Product Change Notification

PCN/20/024/C+N

Product range: Han / Han-Modular

Title: Han-Modular Shielding Frame 24B - External.docx

Current Shielding Frame

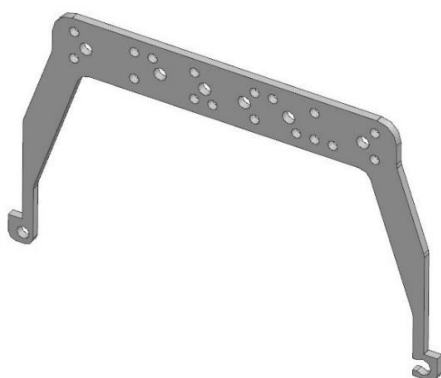
The Han-Modular® shielding frame size 24B will get two additional gaps on both sides as shown on the following drawing:

These two additional gaps improve the handling and termination of modules for bigger wires at the outer positions of the Han-Modular® Hinged Frames size 24 B.
